## Colorado Springs, CO

### **Final Report - Corrections Required** **Application No. DEPN-23-0002**

**Description : proposing to build (4) 3-story apartment buildings with clubhouse and pool**

# VETERANS VICTORY - LOT 1 DEVELOPMENT PLAN

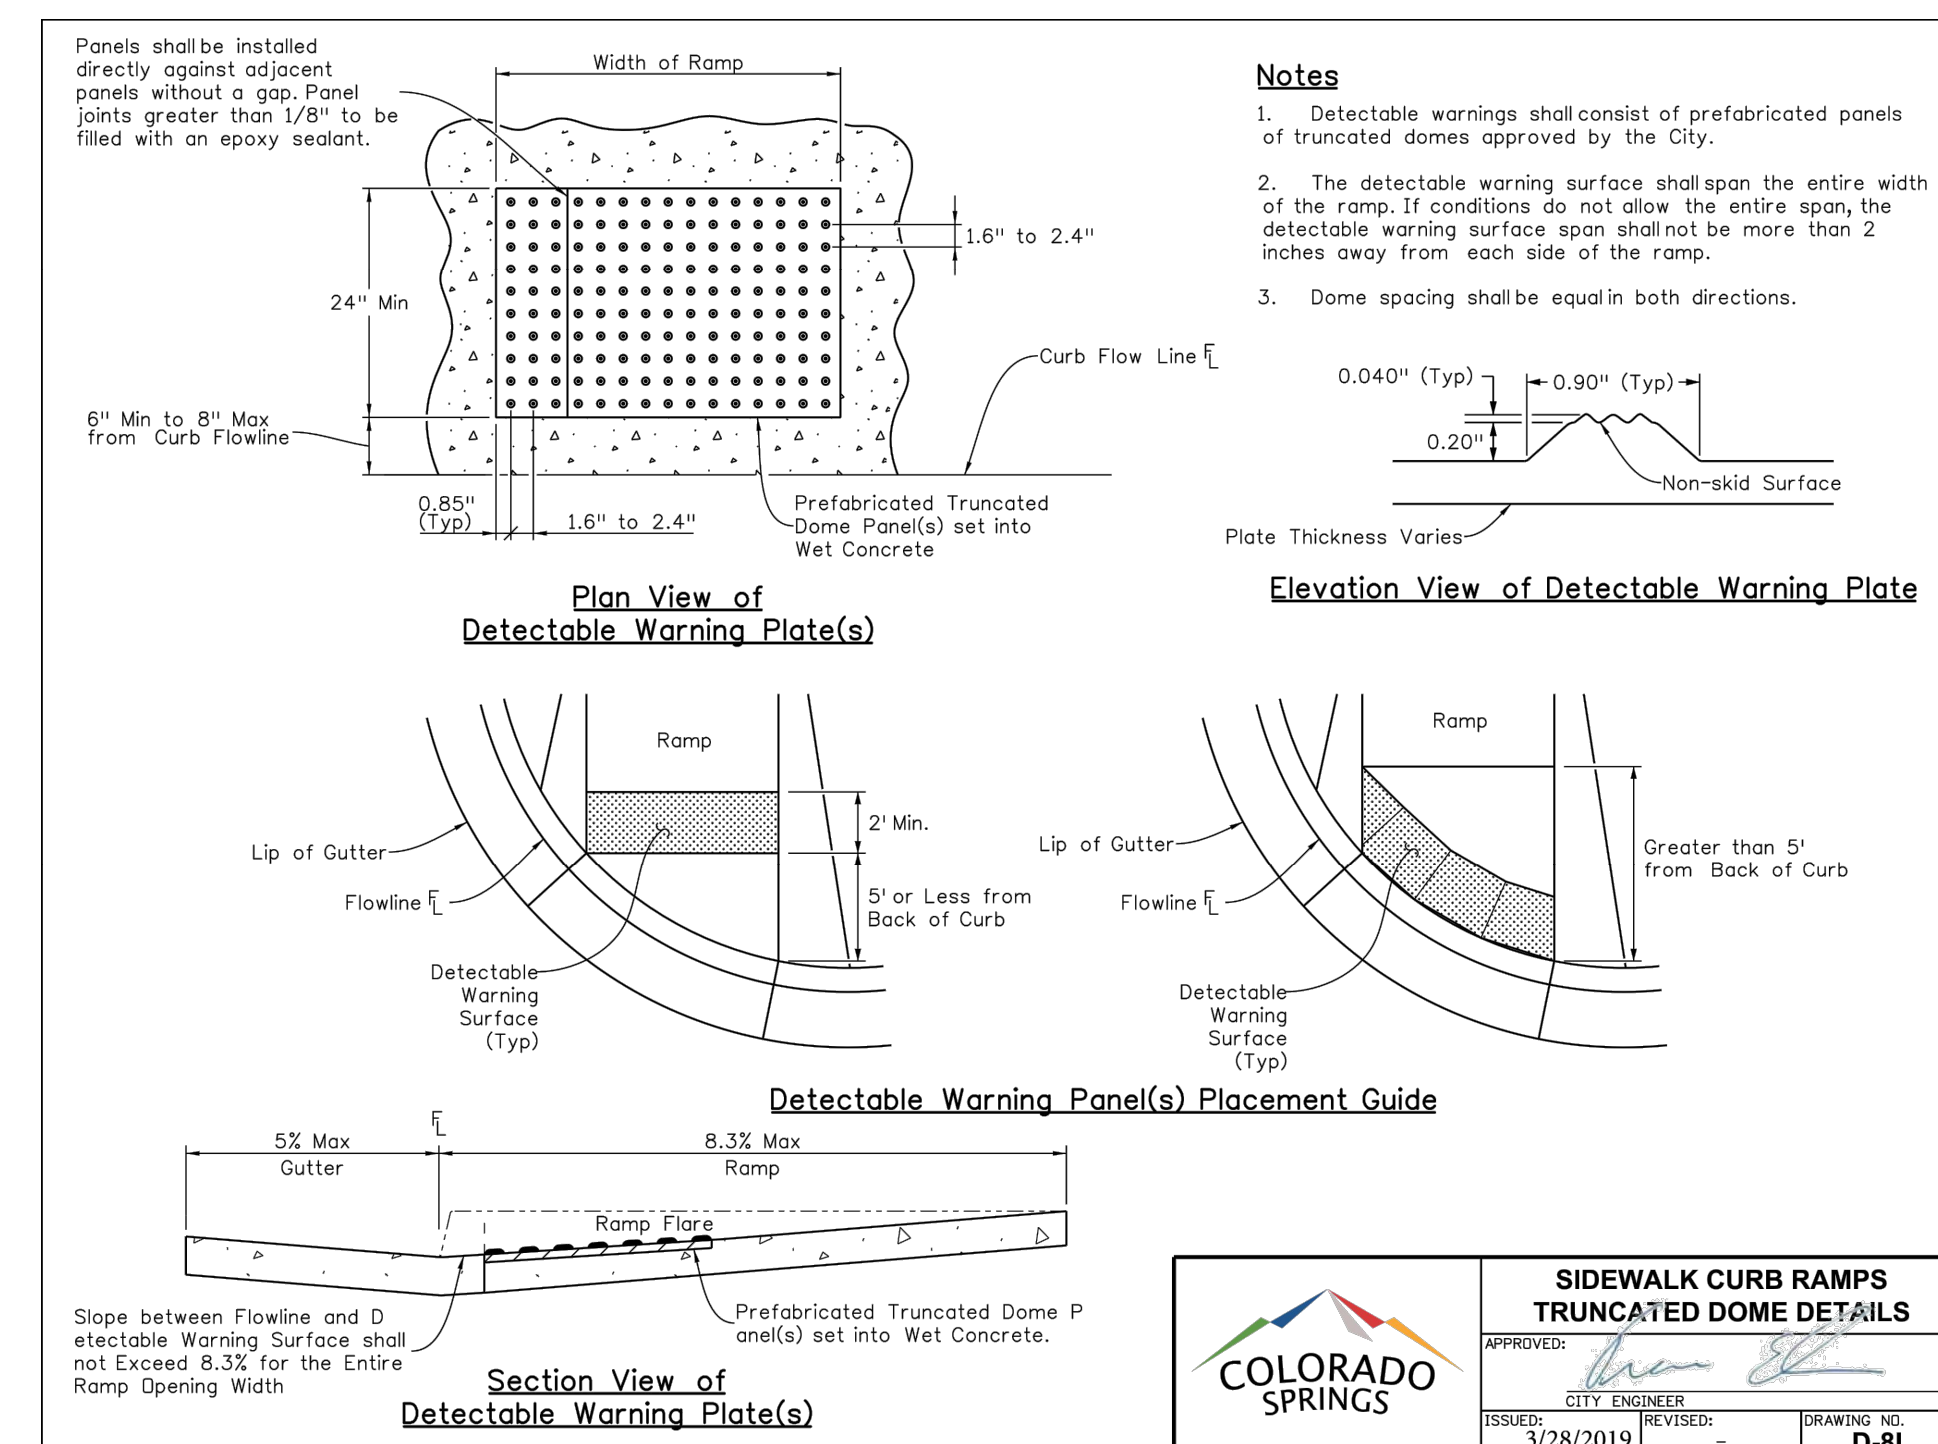
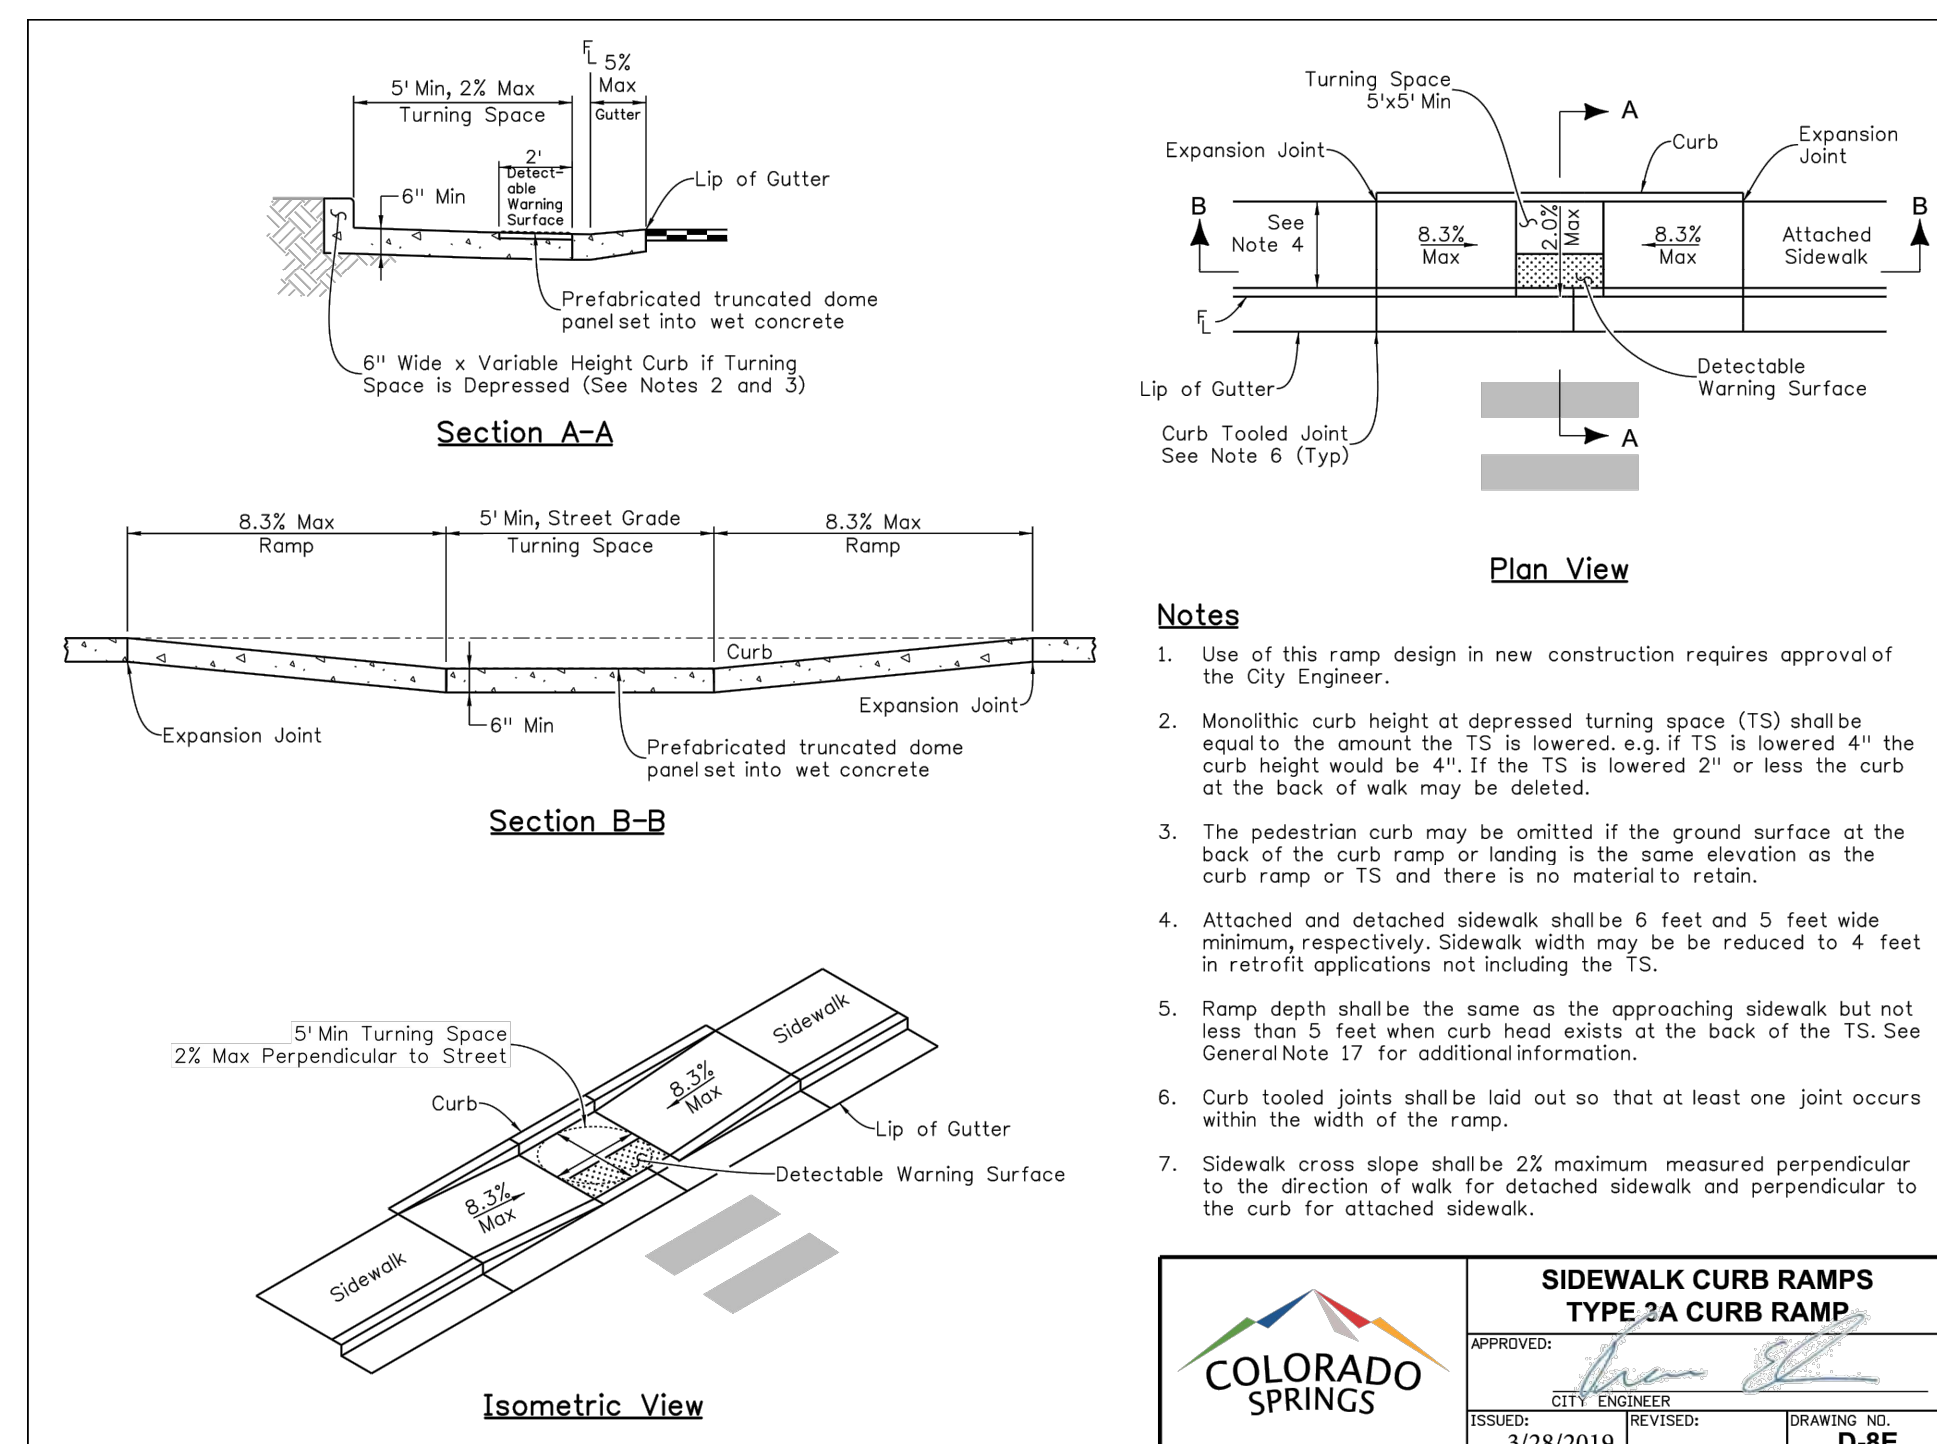
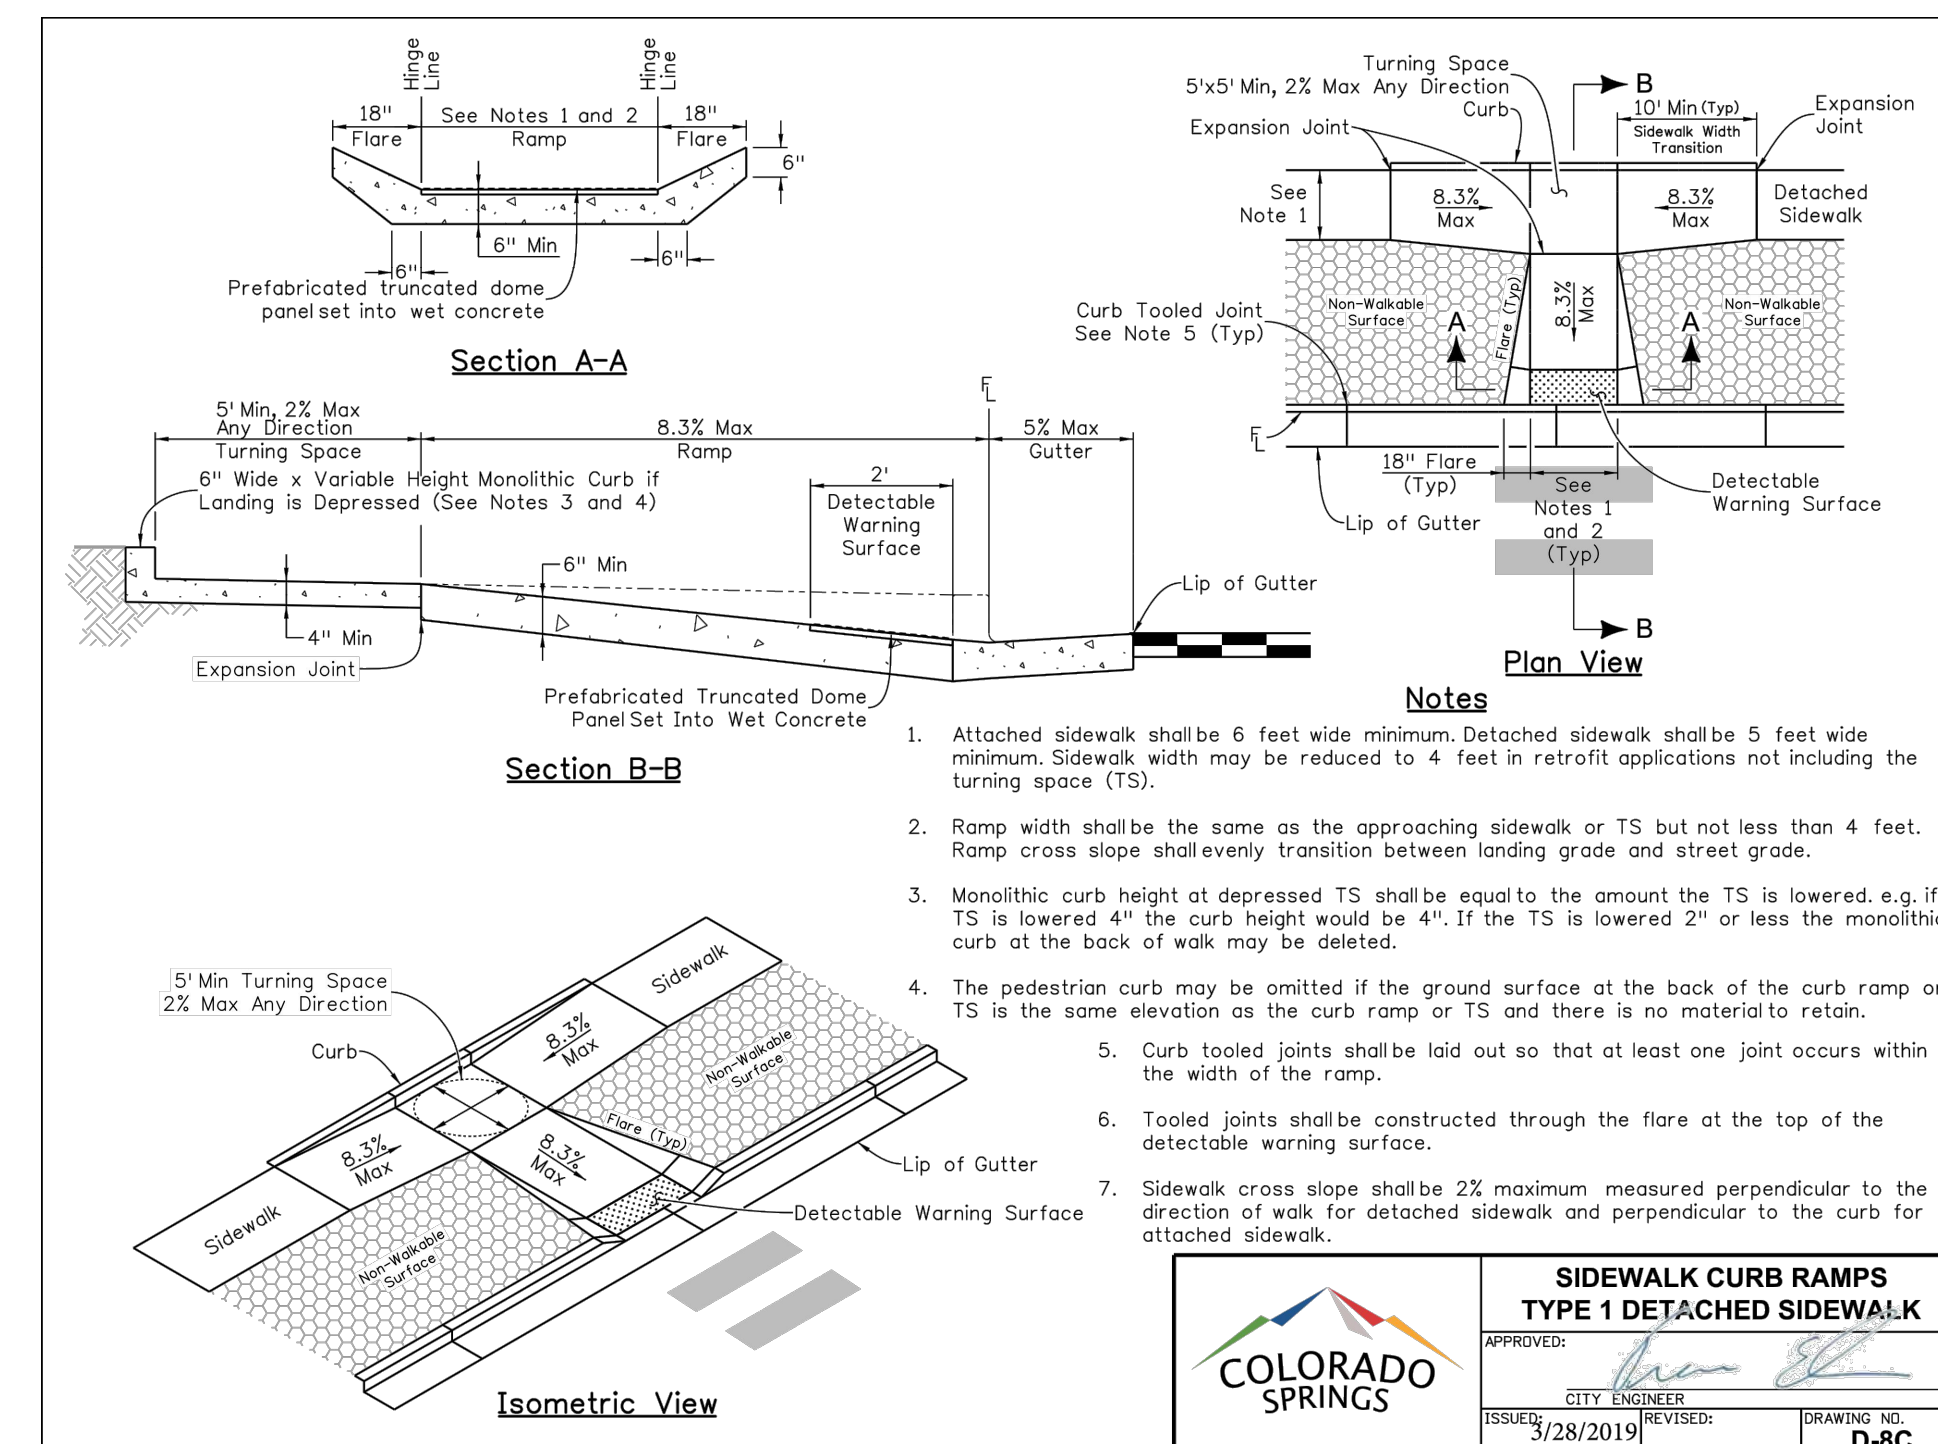
Add DEP-N-23-0002 to each page of the plan set
